STANDARD DEPARTURE CHART-INSTRUMENT

RJFN / NYUTABARU

NIPPO SEVEN DEPARTURE

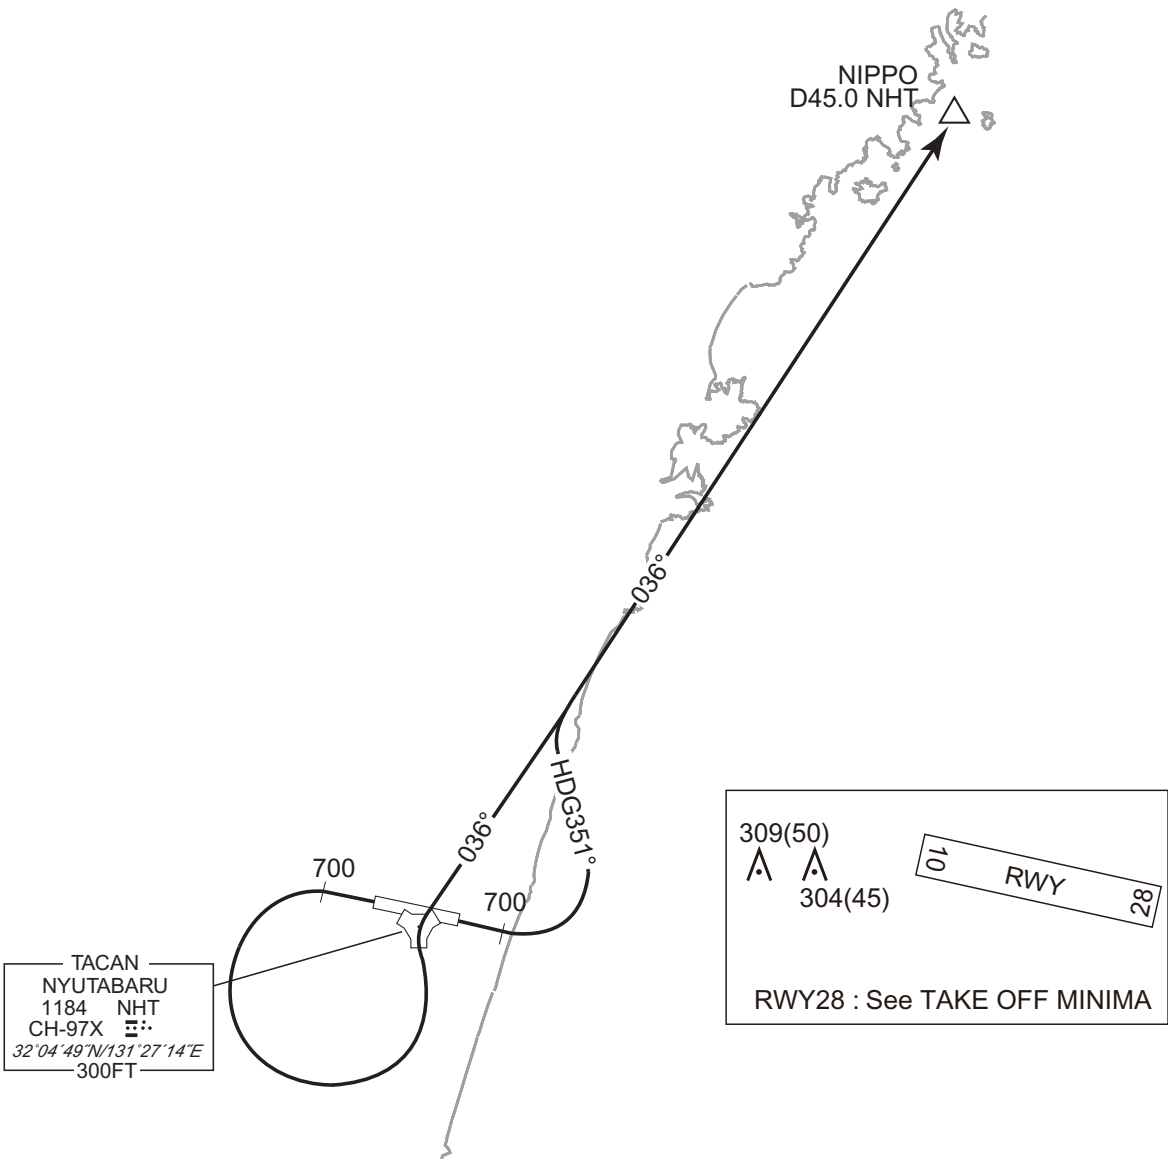
CHANGE : PROC renamed(NIPPO SEVEN DEPARTURE). PROC course(NIPPO SEVEN DEPARTURE). YATOJI TWO DEPARTURE abolished.
Restriction. Note, OBST added.

TENSO FOUR DEPARTURE

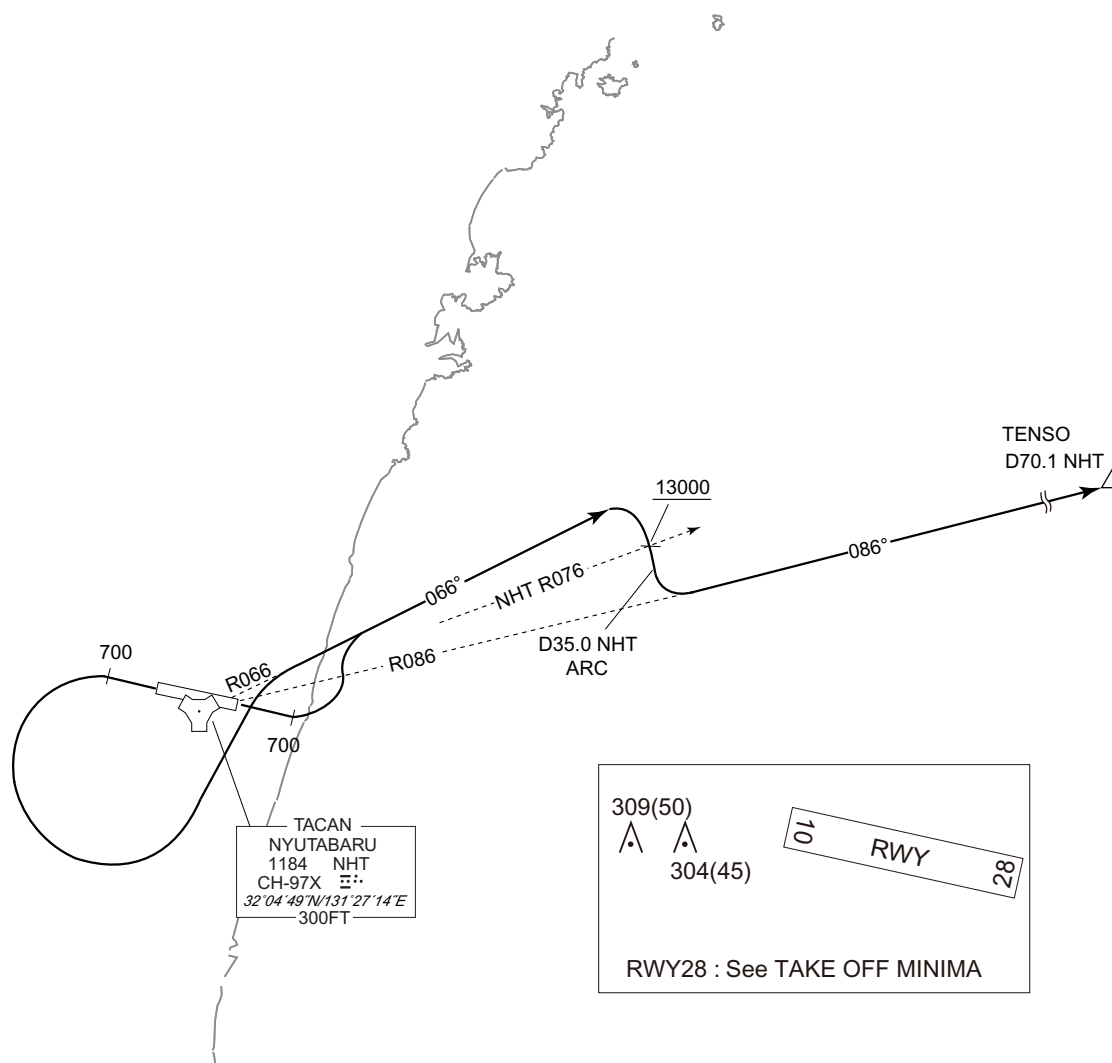
CHANGE : PROC renamed. PROC course. Restriction. Note, OBST added.

SAITO ONE DEPARTURE

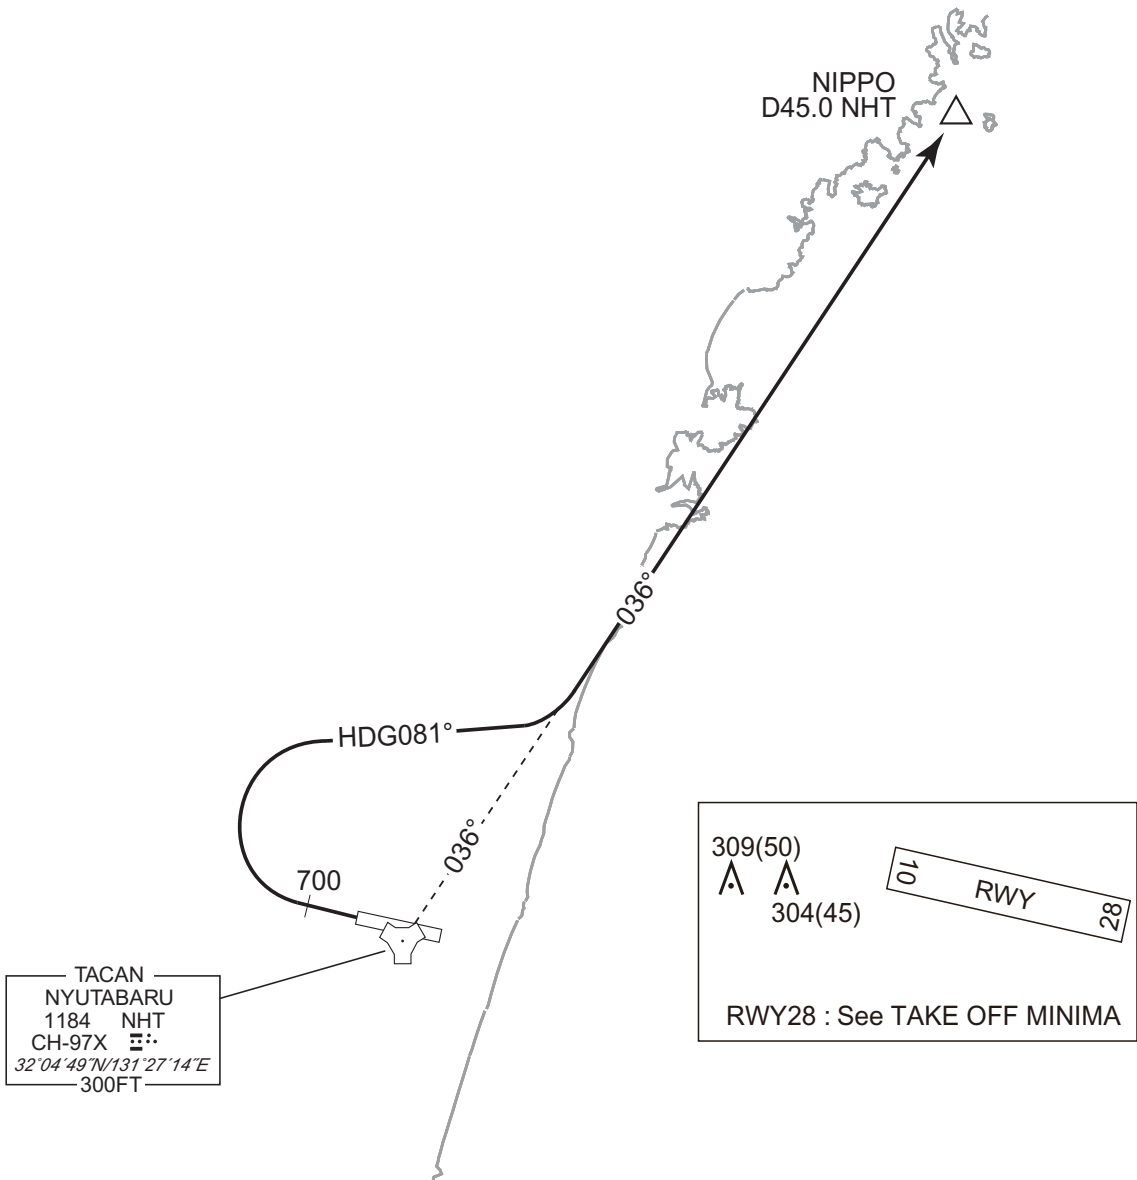
CHANGE : New PROC.

TRANSITION

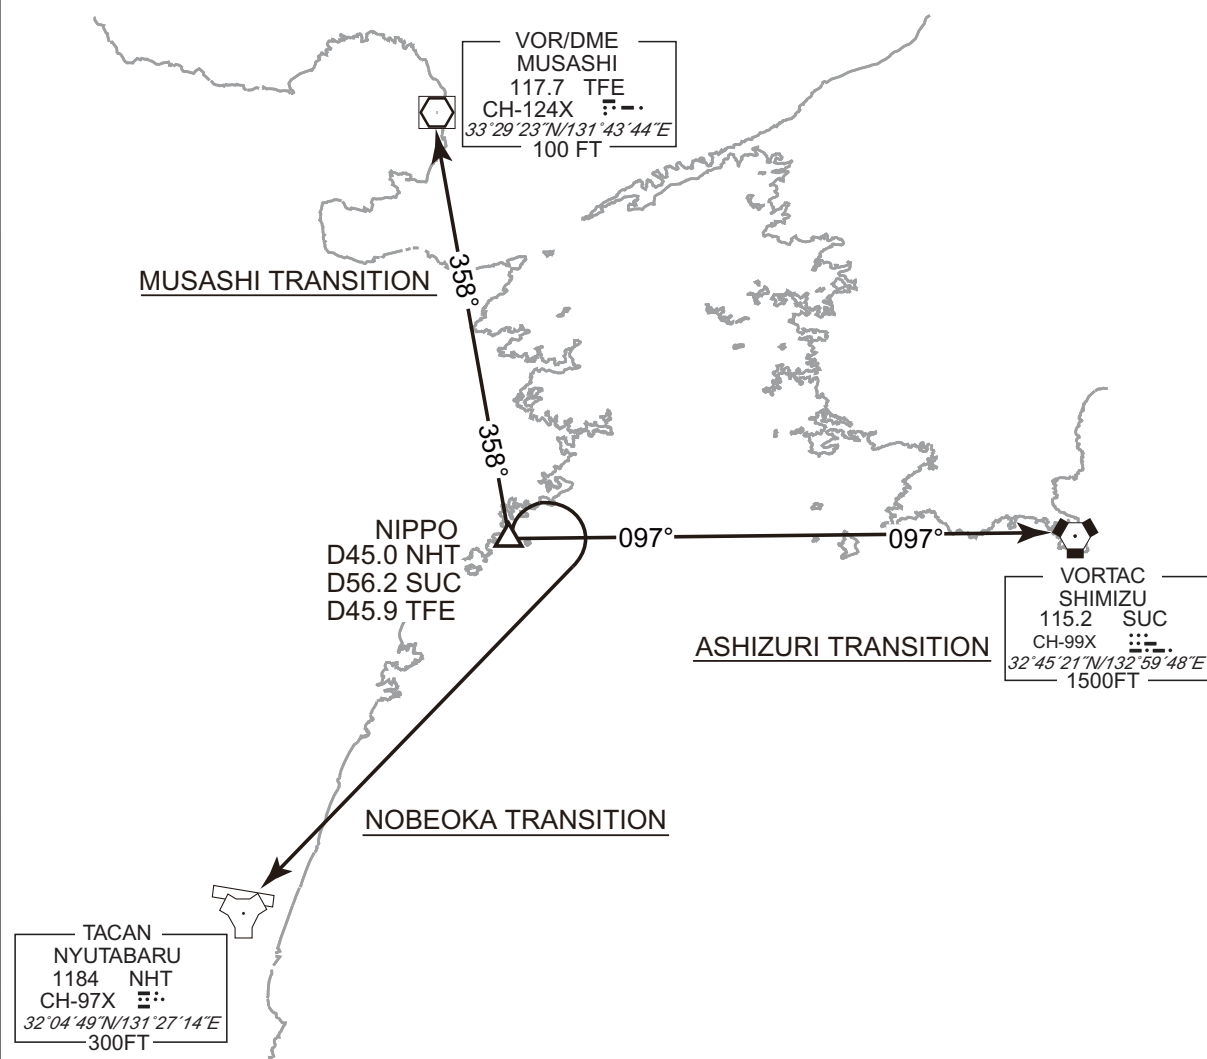
CHANGE : PROC course(NOBEOKA TRANSITION). Description of ASHIZURI TRANSITION, MUSASHI TRANSITION, MUSASHI TRANSITION. ALT restriction.
SOBO TRANSITION abolished.

TENSO ARRIVAL

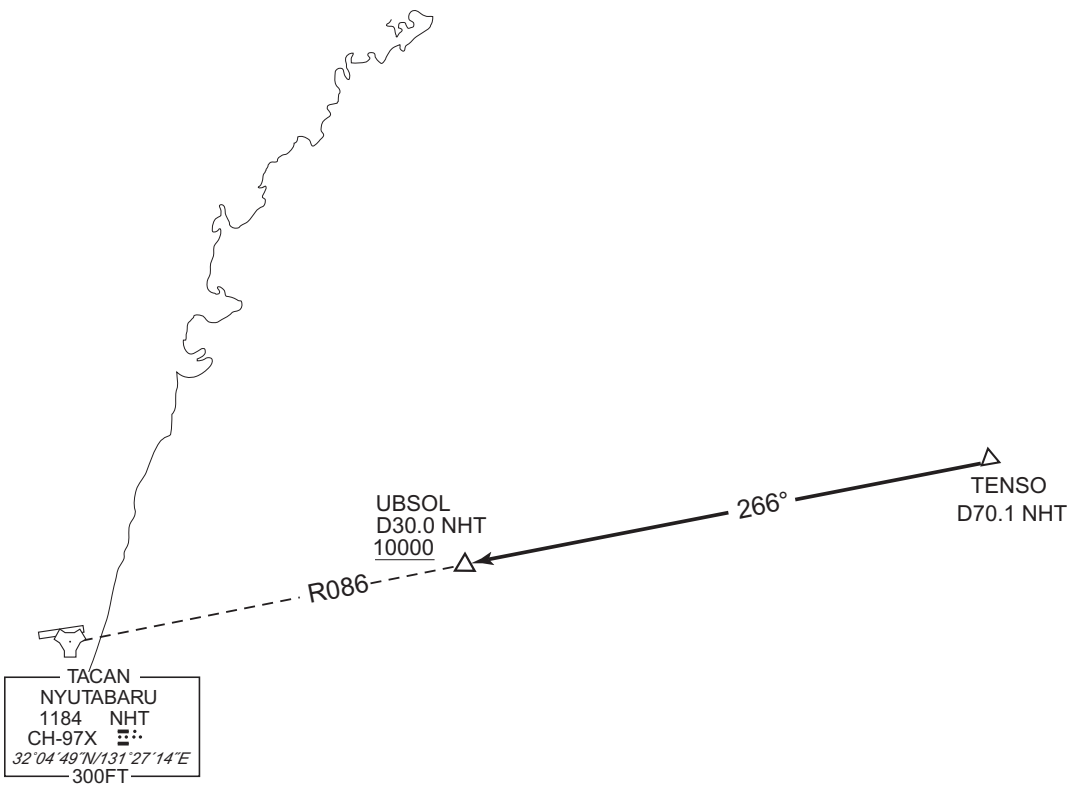
CHANGE : PROC course. UBSOL established. ALT restriction.

TACAN Z RWY28

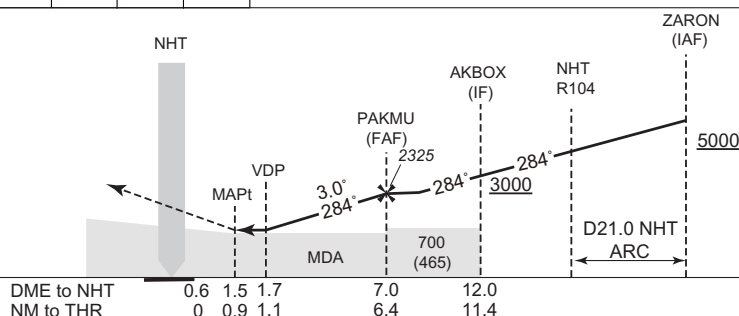
CHANGE : PROC course. Missed APCH course. MINIMA. PAKMU,AKBOX established. NM to THR.ALT(3.0°APCH Path), DME to NHT added. Missed APCH climb gradient MNM added. VAR.

INSTRUMENT APPROACH CHART

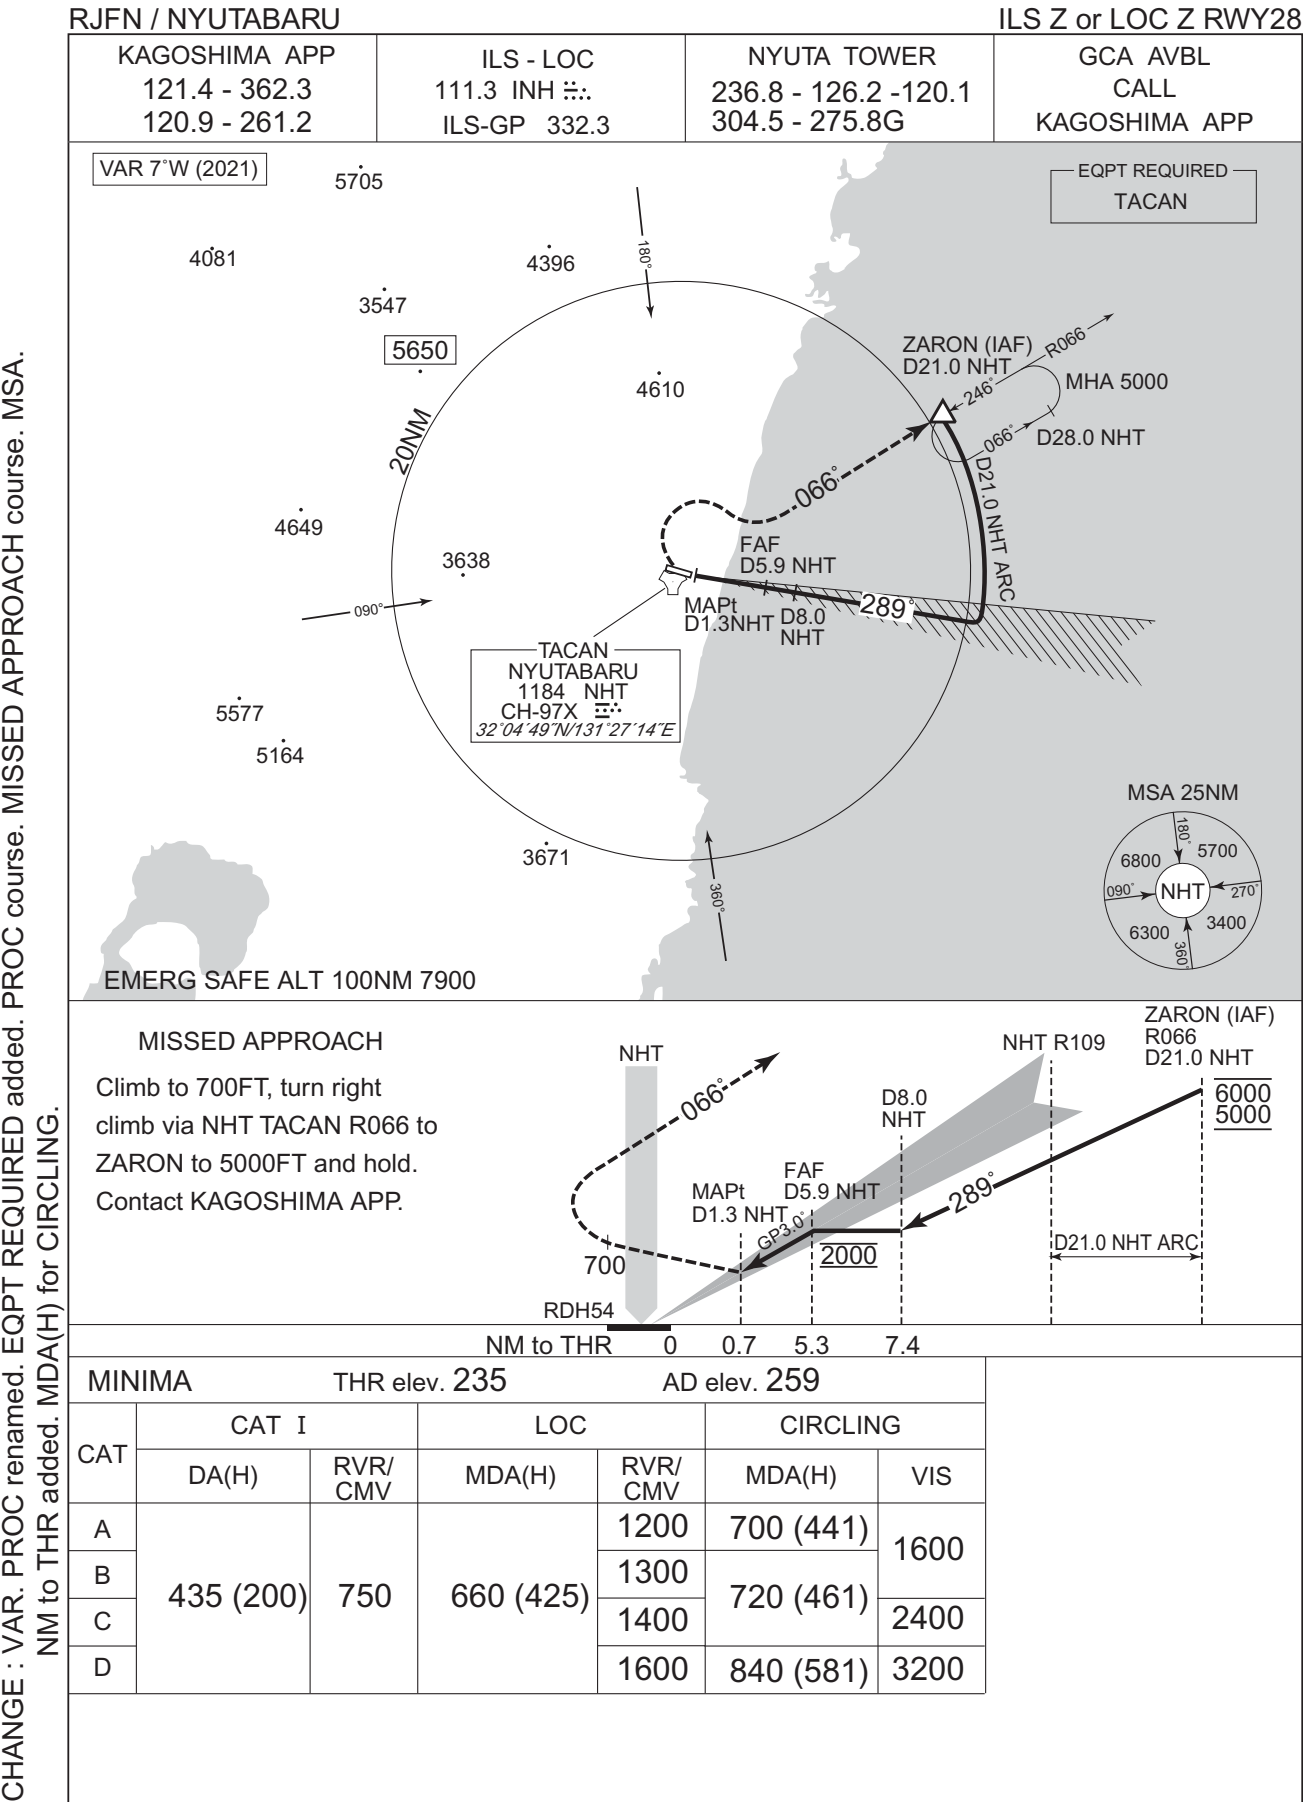
CHANGE : VAR. PROC renamed. EQPT REQUIRED added. PROC course. MISSED APPROACH course. MSA.
NM to THR added. MDA(H) for CIRCLING.

INSTRUMENT APPROACH CHART

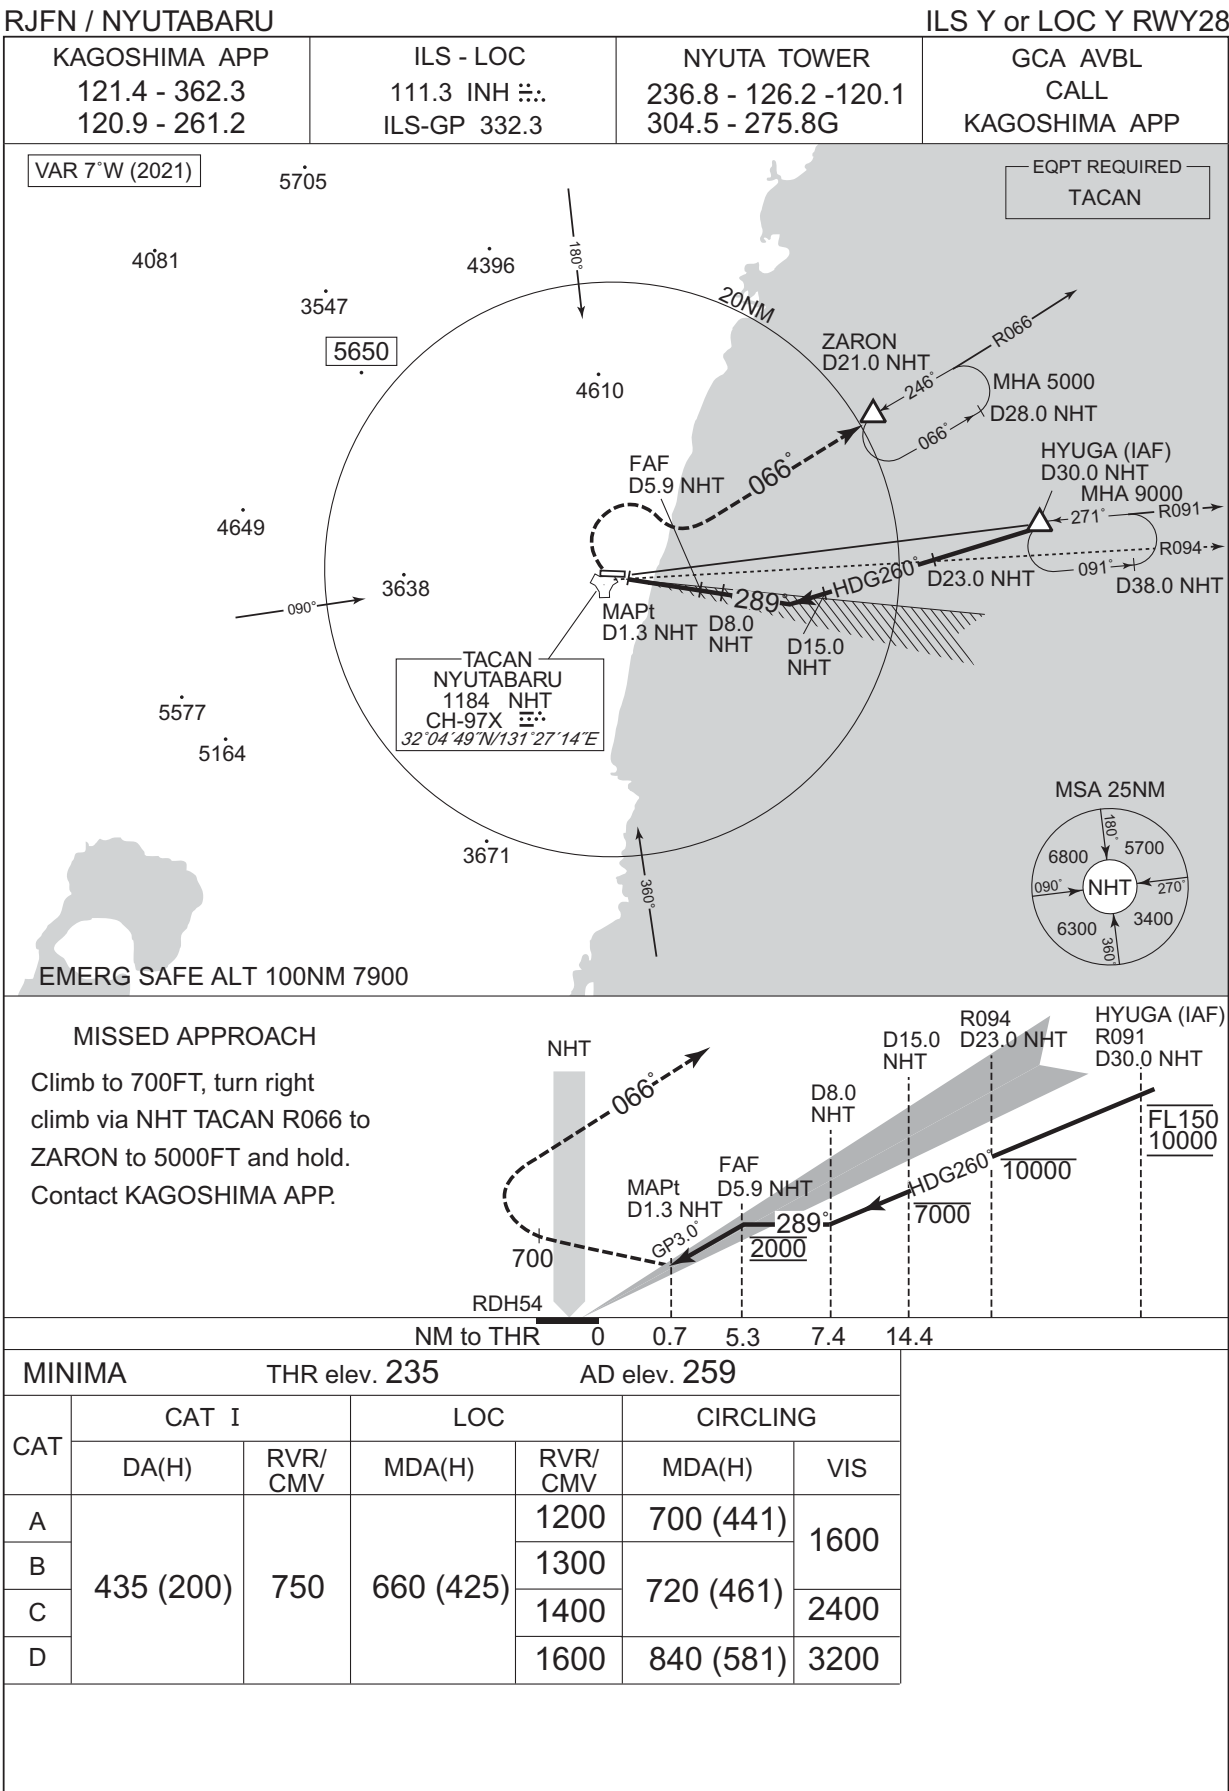
CHANGE : VAR. PROC renamed. EQPT REQUIRED added. PROC course. MISSED APPROACH course. MSA.
NM to THR added. MDA(H) for CIRCLING.
